Access Compliance Report

Public Rights-of-Way

(Curb Ramps)

Intersection ID: 31534	Main Street: ALMORA_DR	Cross Street: SUNMAN_RD	Location: W
ADA ID: 2289BA8B26AF	Ramp Type: PerpDiag	Initial Pass/Fail: Fail	Overall Compliance: No
Codes/Mitigation Info/Possible Solution		Field Measurements/Component Compliance	
Severity Score: 13.75

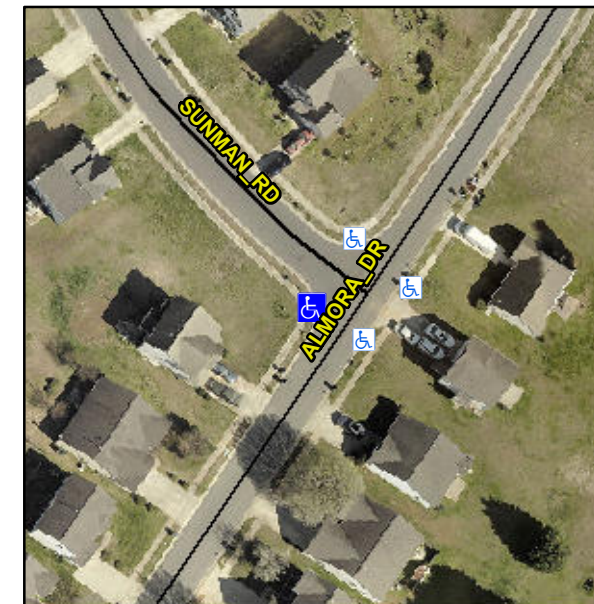
Not Found, R304.2.2, R304.5.3

Compliance	Description	Data	Compliance	Description	Data
N/A	Ramp Length (in)	51.0	No	Ramp Slope (%)	10.2
Yes	Ramp Width (in)	50.5	No	Ramp XSlope (%)	2.6
N/A	Flare Type LT	N/A	N/A	Flare Type RT	N/A
N/A	Flare Slope LT (%)	N/A	N/A	Flare Slope RT (%)	N/A
N/A	Flare Traversable LT?	N/A	N/A	Flare Traversable RT?	N/A
N/A	Landing Length (in)	N/A	N/A	DWS Provided?	N/A
N/A	Landing Width (in)	N/A	N/A	DWS Contrast?	N/A
N/A	Landing Slope (%)	N/A	N/A	DWS Length (in)	N/A
N/A	Landing X Slope (%)	N/A	N/A	DWS Full Width?	N/A
N/A	Landing Curb? (Y/N)	N/A	N/A	DWS Offset (in)	N/A
N/A	Shared Landing?	N/A			
N/A	Gutter Ponding?	N/A	N/A	Gutter Slope (%)	N/A
N/A	Gutter Lip Ht (in)	N/A	N/A	Gutter X Slope (%)	N/A
N/A	Painted X Walk1?	No	N/A	Painted X Walk2?	No
	X Walk 1 Direction	To E		X Walk 2 Direction	To NE
N/A	X Walk 1 Width (in)	N/A	N/A	X Walk 2 Width (in)	N/A
	X Walk 1 Slope (%)	9.7		X Walk 2 Slope (%)	3.4
	X Walk 1 X Slope (%)	0.4		X Walk 2 X Slope (%)	4.6

Remove & Replace Curb Ramp With Two New Directional Ramps or Equivalent.
